Illinois Tollway Base Sheet Revisions
--

Section M		Base Sheet Drawings	
Drawing	Modification Summary	Effective: 03-01-2024	
Overhead Sign (OHS)-Series 720			
M-OHS-722	OVERHEAD SIGN STRUCTURE ENTRANCE MONOTUBE TYPE (STEEL) MAINLINE SUMMARY AND BILL OF MATERIAL		
	Added pay item details for double face barrier to the bill of materials.		
M-OHS-723	OVERHEAD SIGN STRUCTURE EXIT MONOTUBE TYPE (STEEL) MAINLINE SUMMARY AND BILL OF MATERIAL		
	Added pay item details for double face barrier to the bill of materials.		
M-OHS-729	OVERHEAD SIGN STRUCTURE ITS GANTRY FRAME (STEEL) SINGLE SPAN STRUCTURE DETAILS

MATERIAL SPECIFICATIONS FOR STRUCTURAL STEEL AND FASTENERS

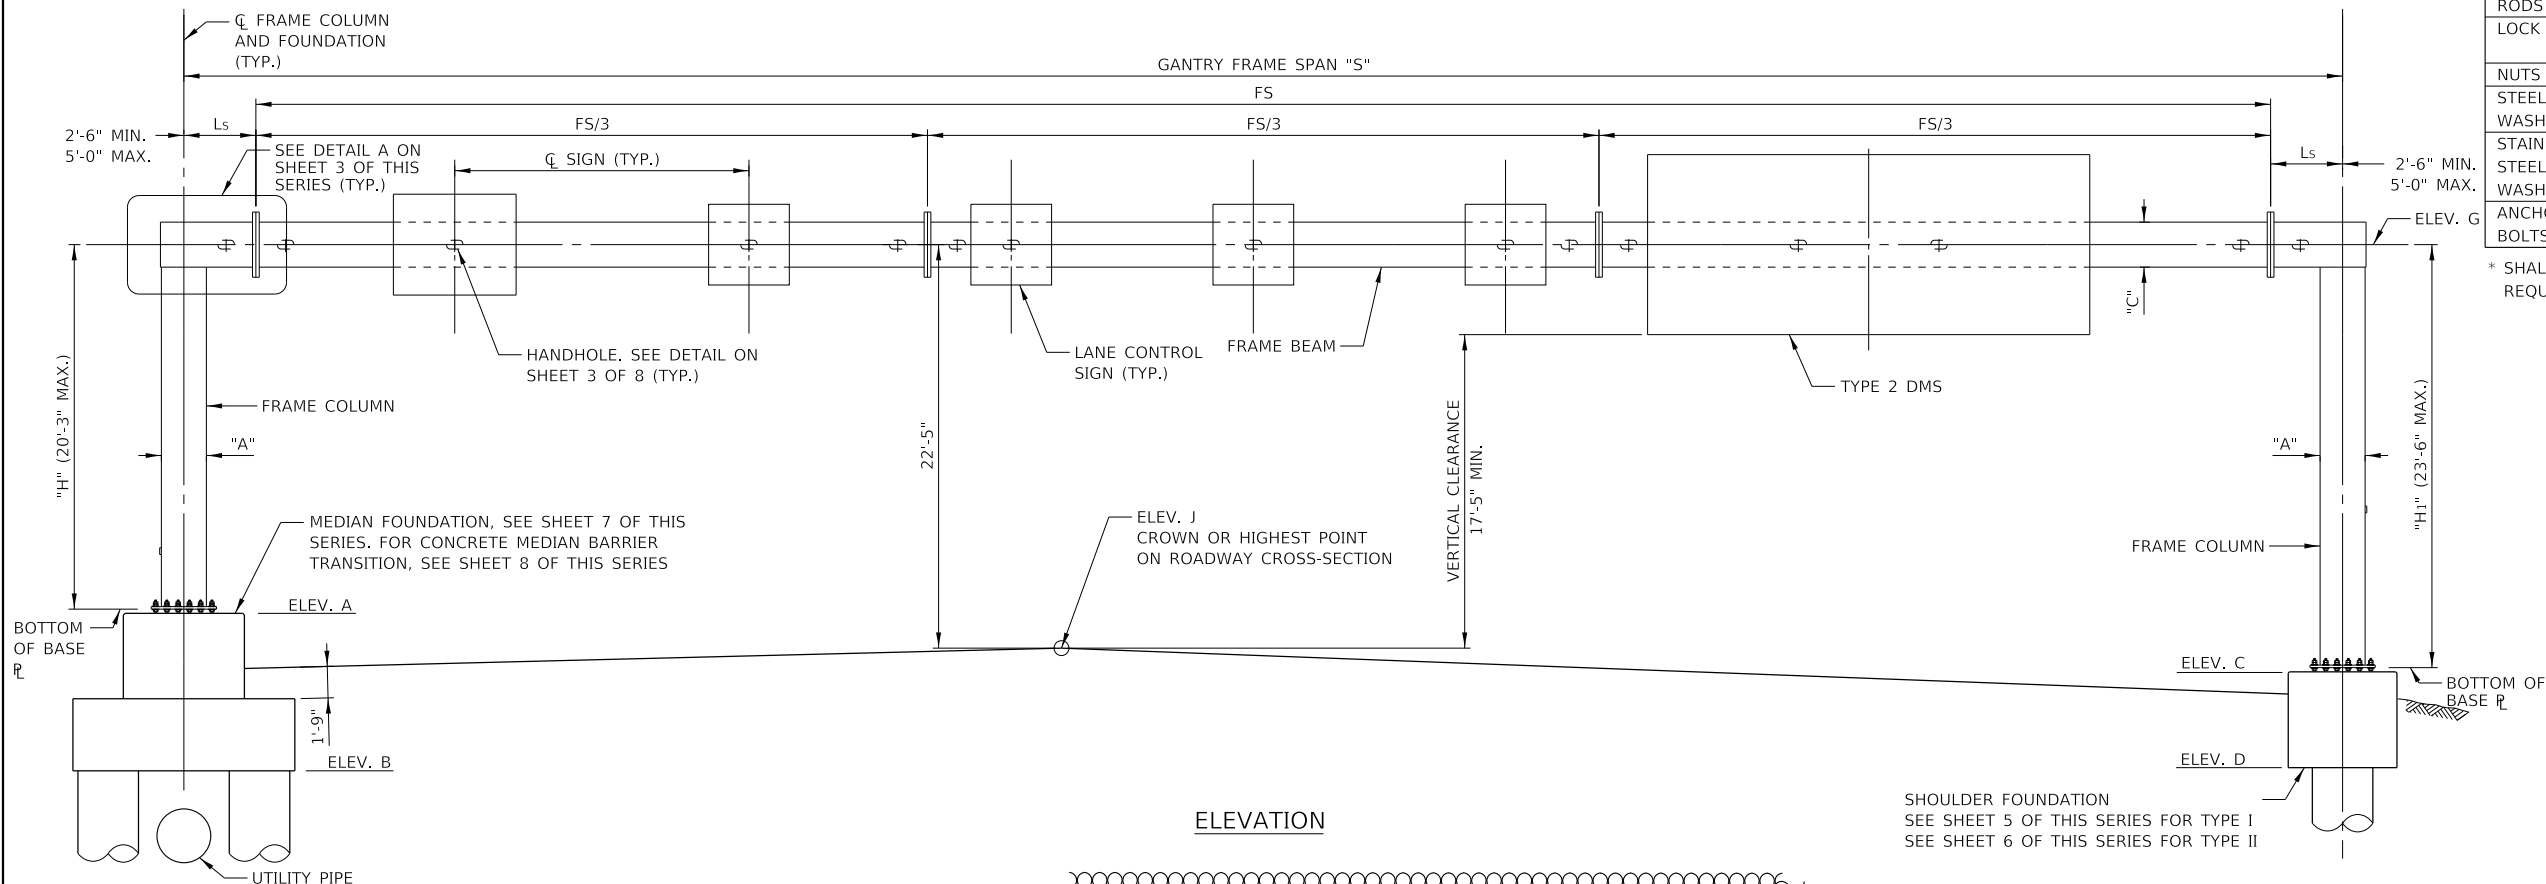
Sheet 1	Changed the material specification of HSS from ASTM A618 Grade III to ASTM A1065 Grade 50 with additional Charpy V-Notch Impact Energy Requirements.

ELEMENT OF STRUCTURE	SPECIFICATION	F _y (ksi)	F _u (ksi)
STRUCTURAL STEEL TUBE FRAME (HSS)	*ASTM A1065 GRADE 50	50	60
STRUCTURAL STEEL TUBE MOUNTING BEAMS (HSS)	ASTM A500 GRADE B	46	58
STEEL SHAPES	ASTM A709, GRADE 50	50	65
STEEL PLATES	ASTM A572 GR. 50 OR ASTM A709 GR. 50	50	65
STEEL BOLTS	ASTM 325 TYPE 1	--	105
SIGN BRACKET RODS	ASTM A307	--	60
LOCK NUTS	ASTM A194 GR. 8F OR ASTM A194 GR. 2H	--	--
NUTS	ASTM A563 GRADE DH	--	--
STEEL WASHERS	ASTM F436	--	--
STAINLESS STEEL WASHERS	ASTM A240, TYPE 302	--	--
ANCHOR BOLTS	AASHTO M 314 OR ASTM F1554	55	75

* SHALL CONFORM TO THE CHARPY-V-NOTCH IMPACT ENERGY REQUIREMENT, ZONE 2

ELEVATION
SHOULDER FOUNDATION TYPE II

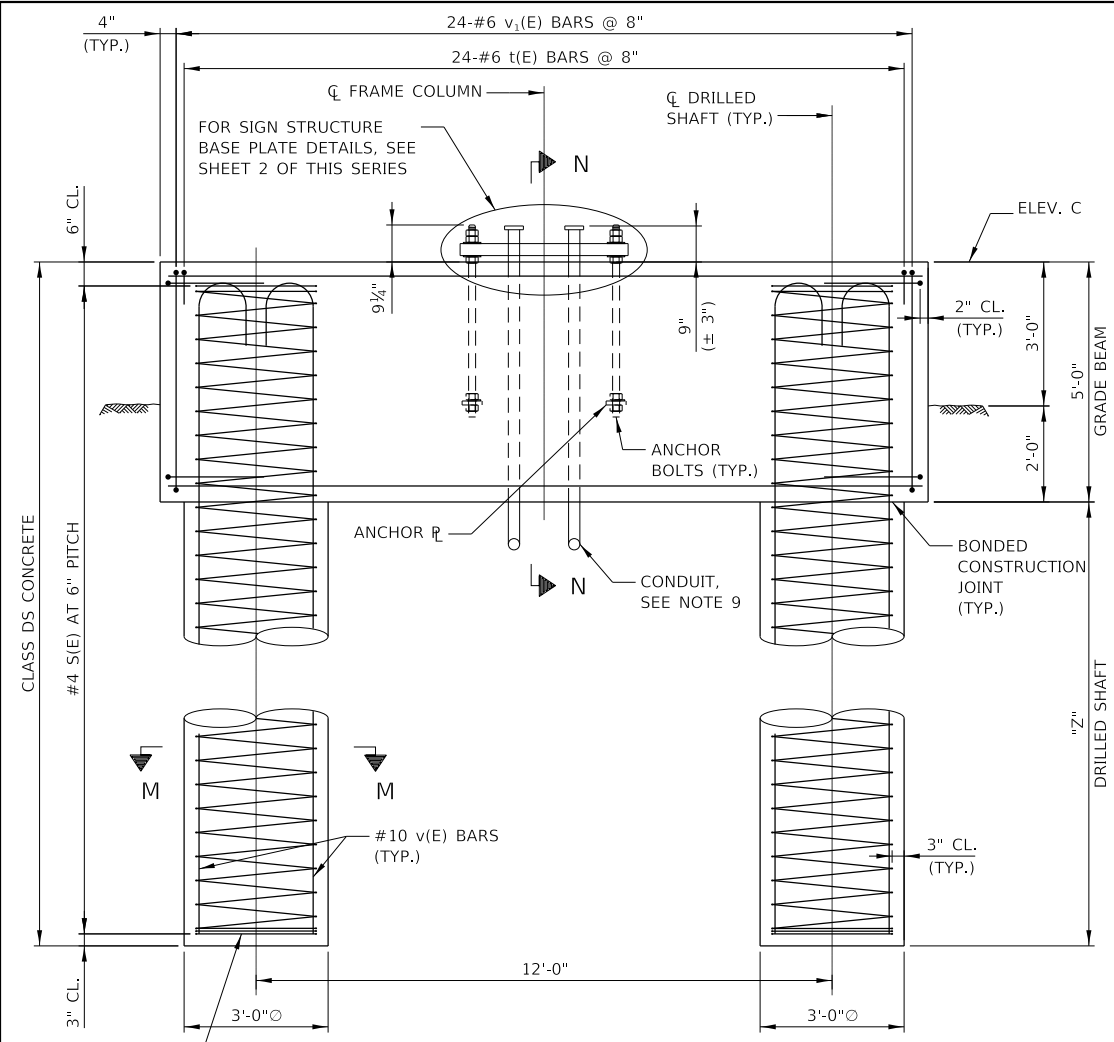
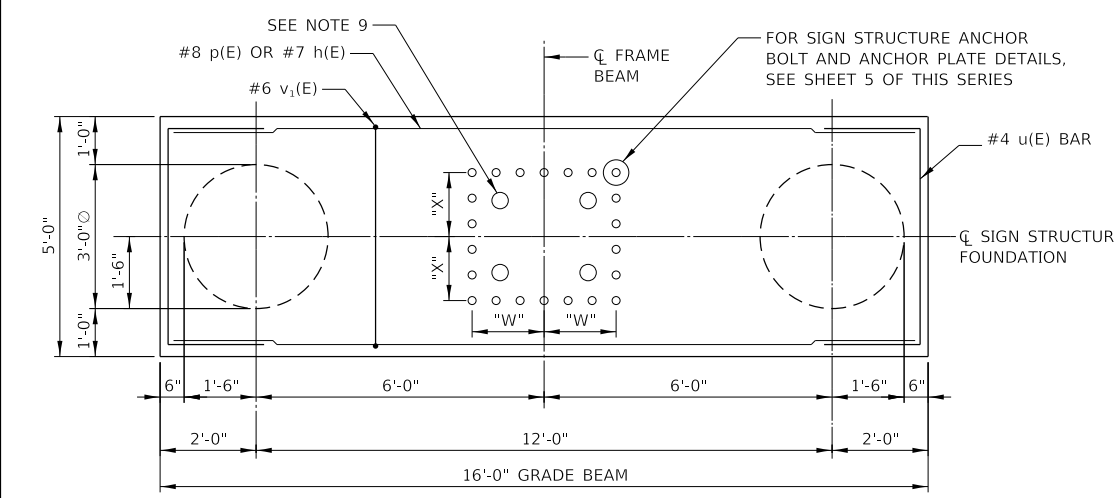
Sheet 6	Section A-A is drawn to clarify the new connection details.		
Sheet 6	Revised the orientation and number of anchor bolts to match with base plate in Shoulder Foundation Type II Plan.		
M-OHS-730	OVERHEAD SIGN STRUCTURE ITS GANTRY FRAME (STEEL) TWO-SPAN STRUCTURE DETAILS

ELEVATION

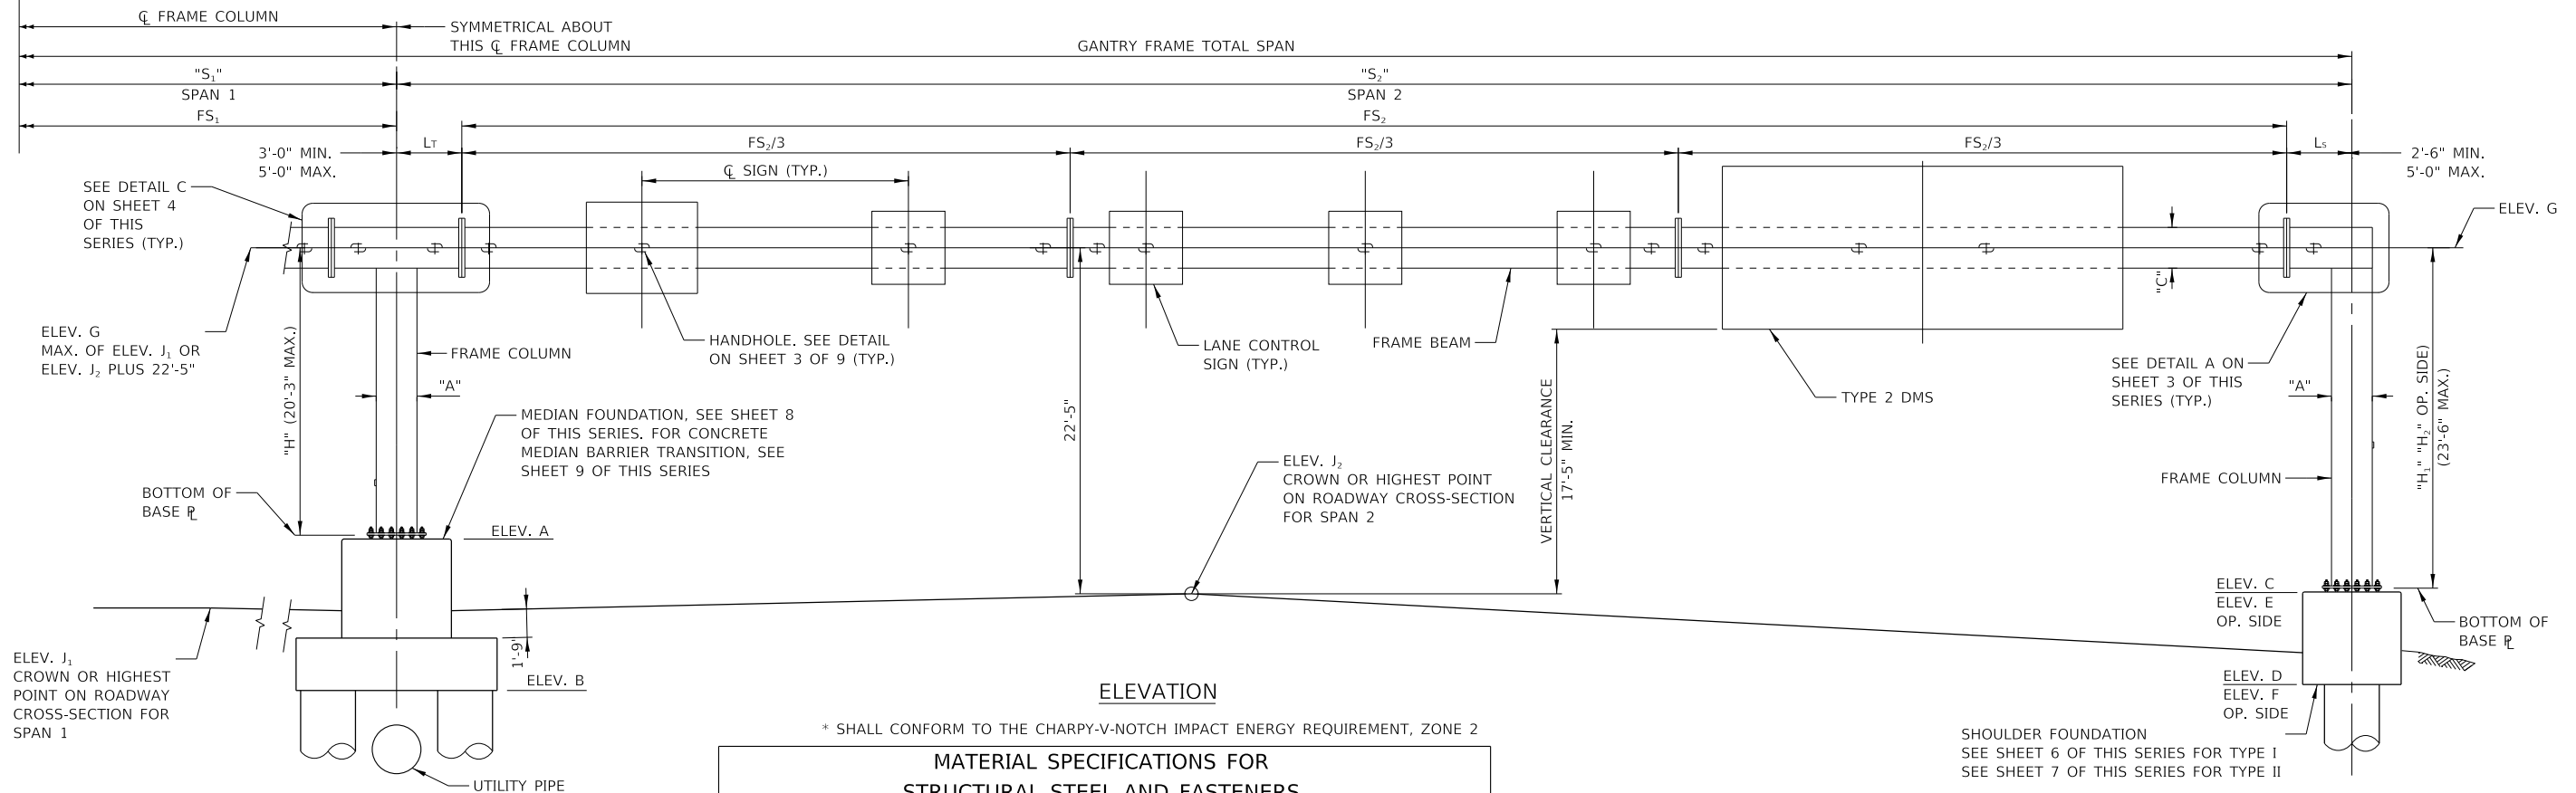
Sheet 1	Changed the material specification of HSS from ASTM A618 Grade III to ASTM A1065 Grade 50 with additional Charpy V-Notch Impact Energy Requirements.

* SHALL CONFORM TO THE CHARPY-V-NOTCH IMPACT ENERGY REQUIREMENT, ZONE 2

VERSION: 2024-03 STANDARD: M-OHS-730 SHEET: 7 OF 9

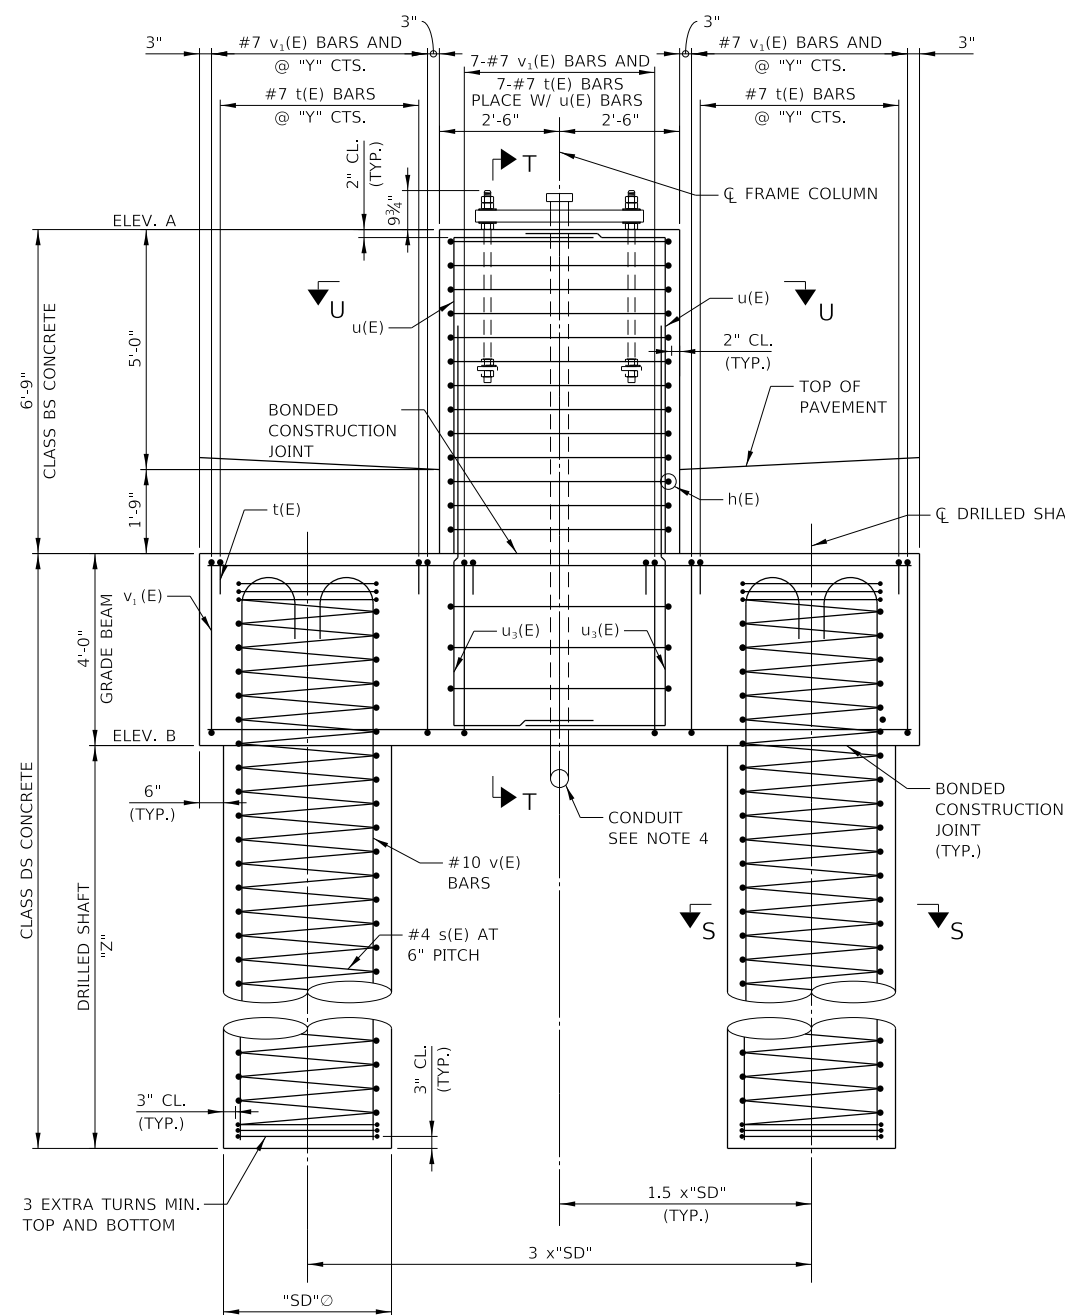
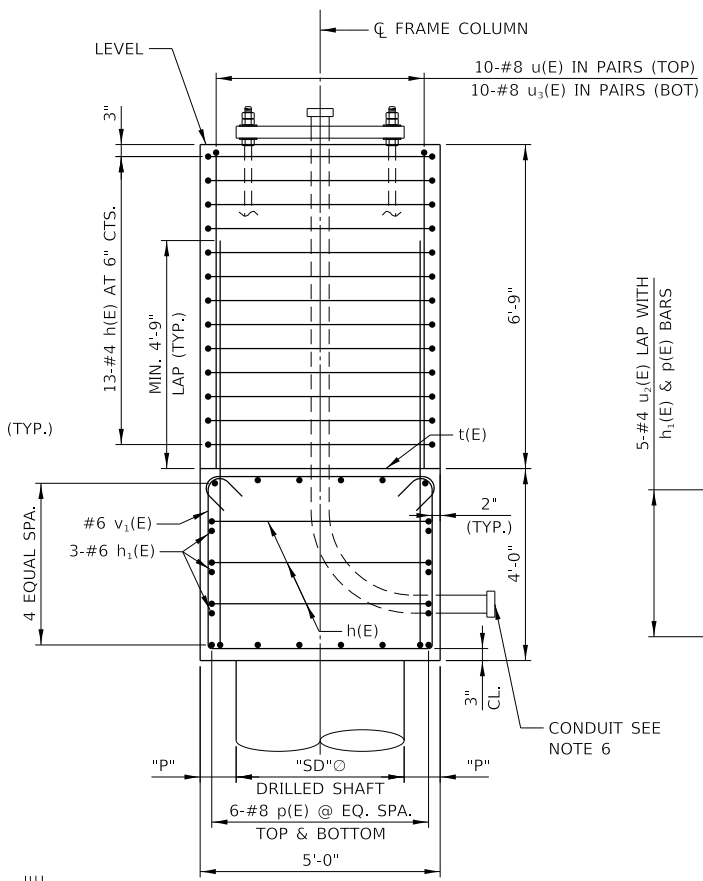
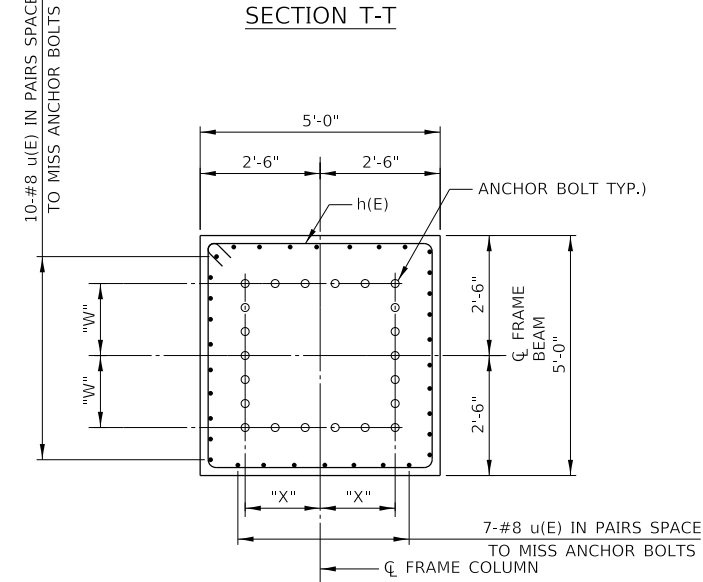
Sheet 7	Section A-A is drawn to clarify the new connection details.		
Sheet 7	Revised the orientation and number of anchor bolts to match with base plate in Shoulder Foundation Type II Plan.
